Notice of Allowability**Application No.**

10/619,441

LEE ET AL.

EXAMINER'S AMENDMENT

Fig. 1

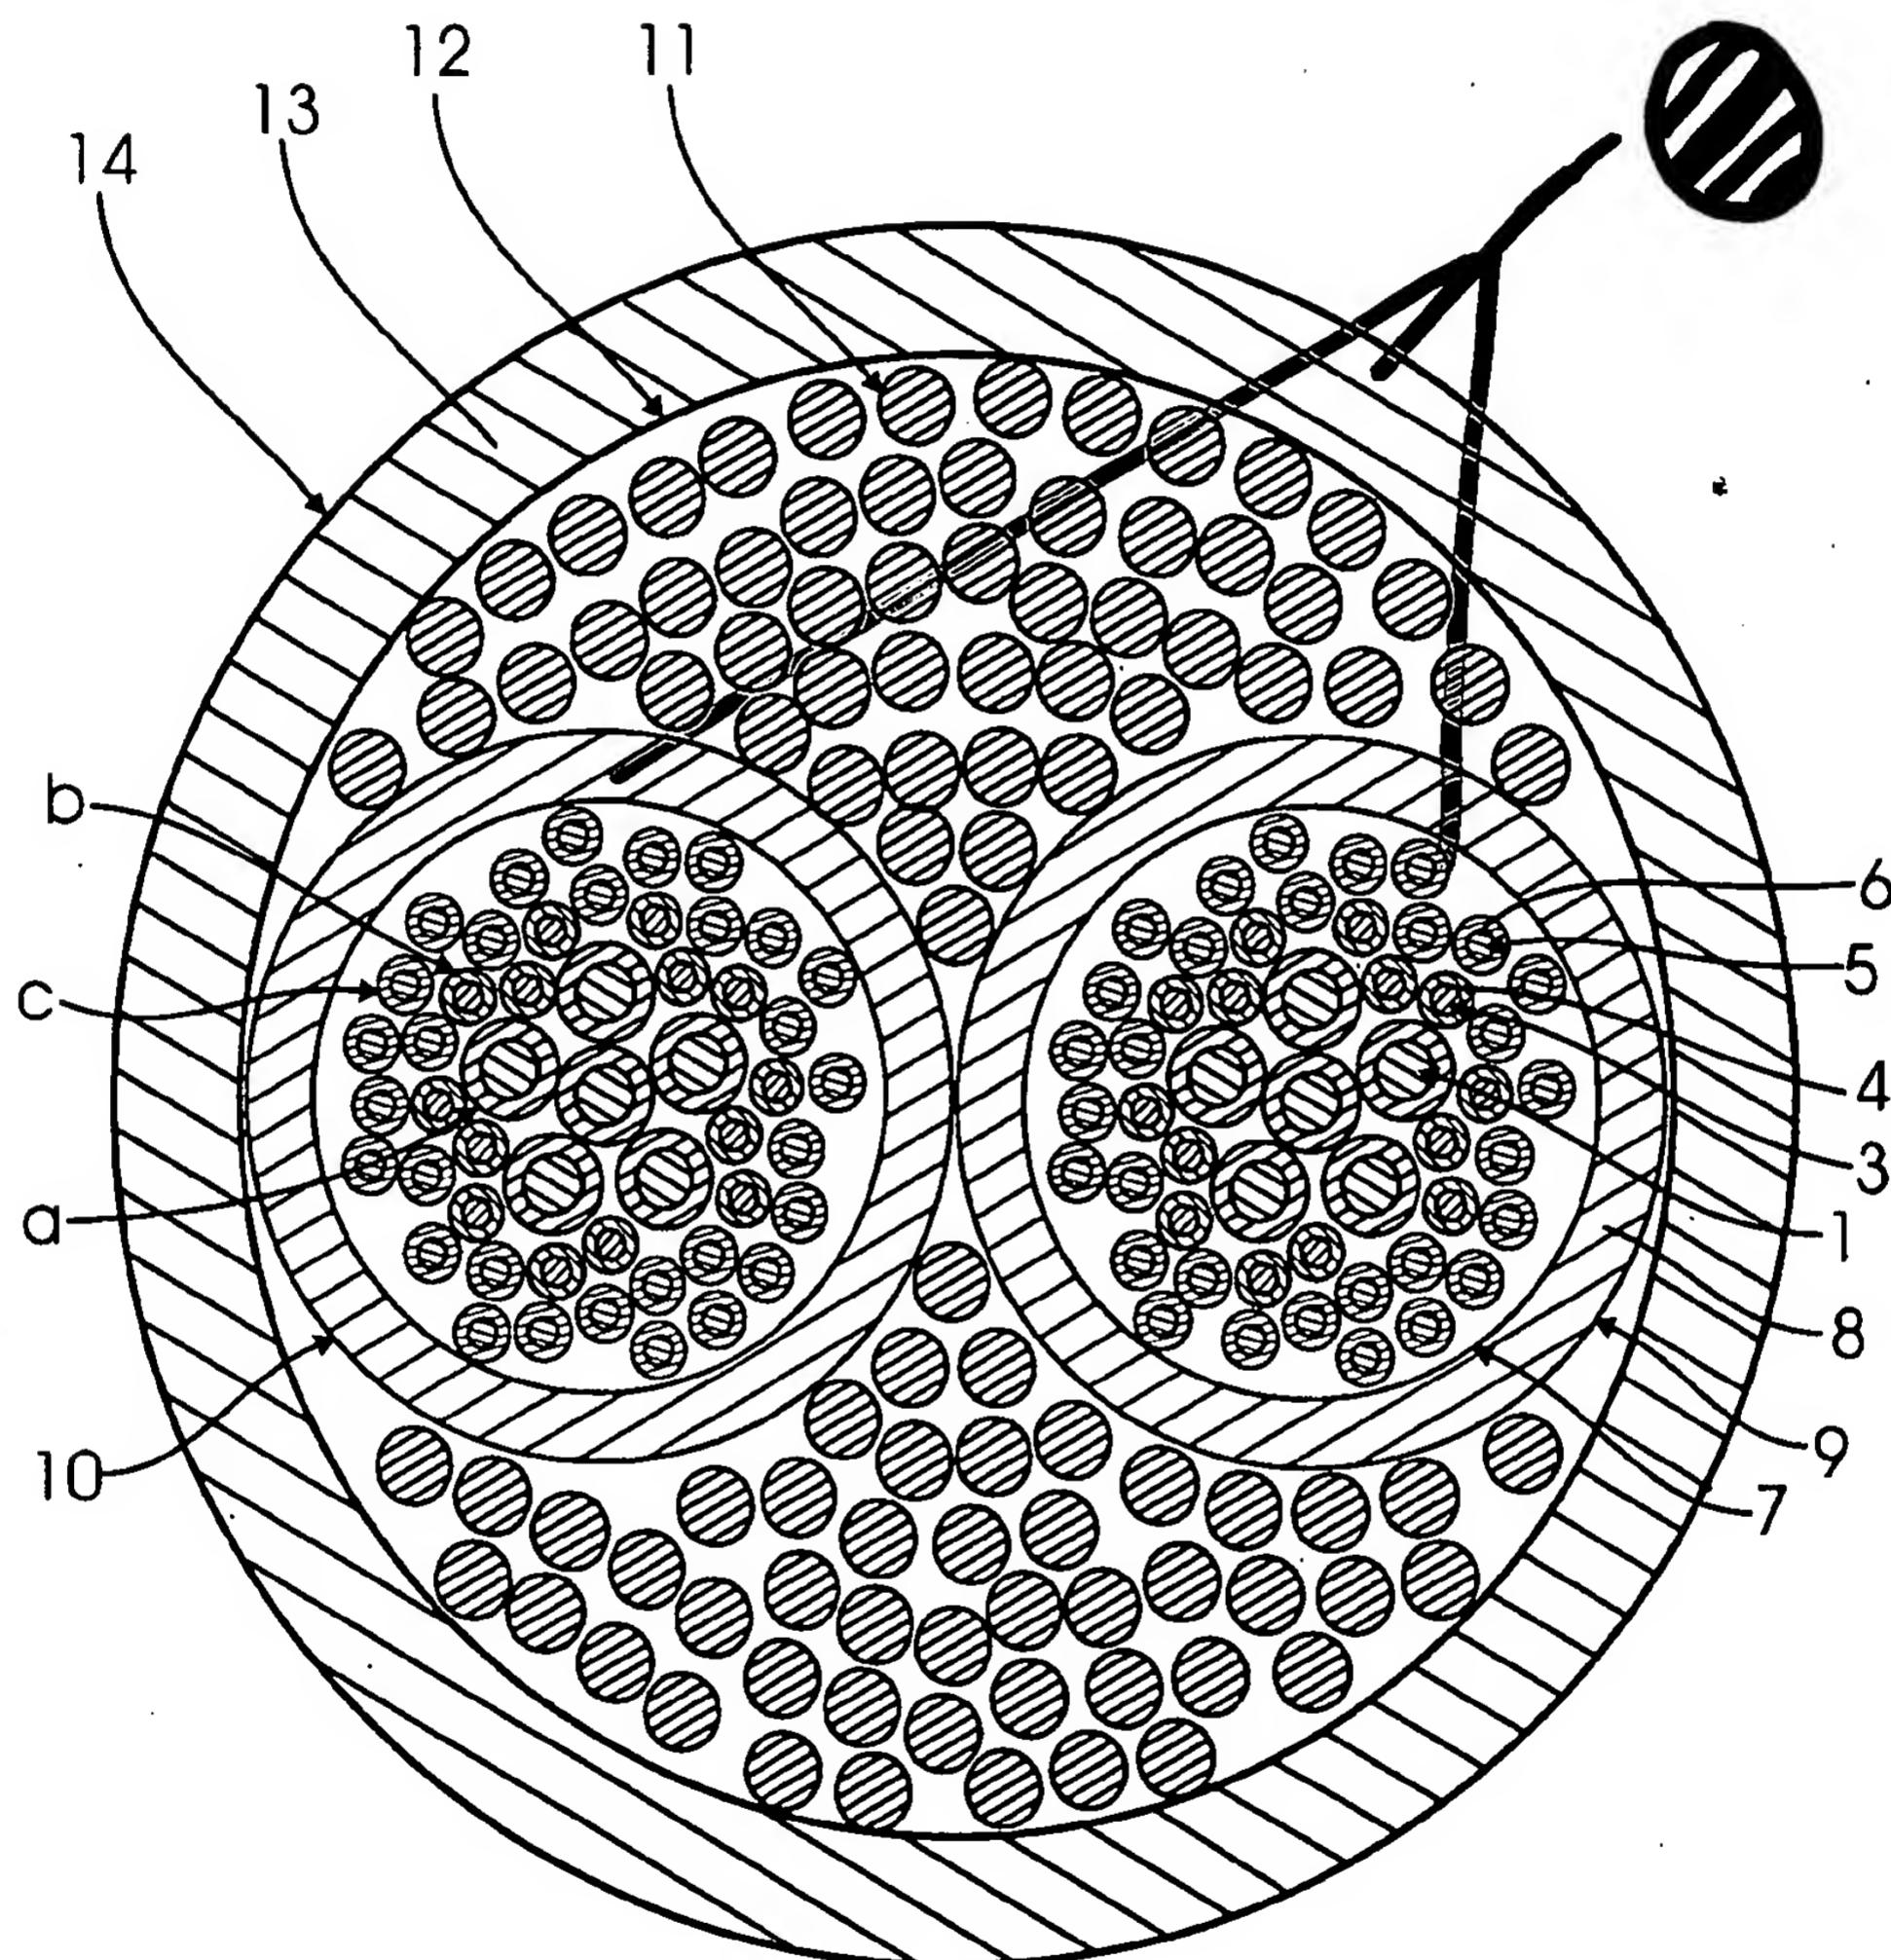
2. The following changes to the drawings have been approved by the examiner and agreed upon by applicant: The insulation and conductor materials will be illustrated as denoted on the enclosed drawing correction. In order to avoid abandonment of the application, applicant must make these above agreed upon drawing changes.

CROSS HATCH ALL
INSULATION AS
SHOWN IN FIGS
1-2
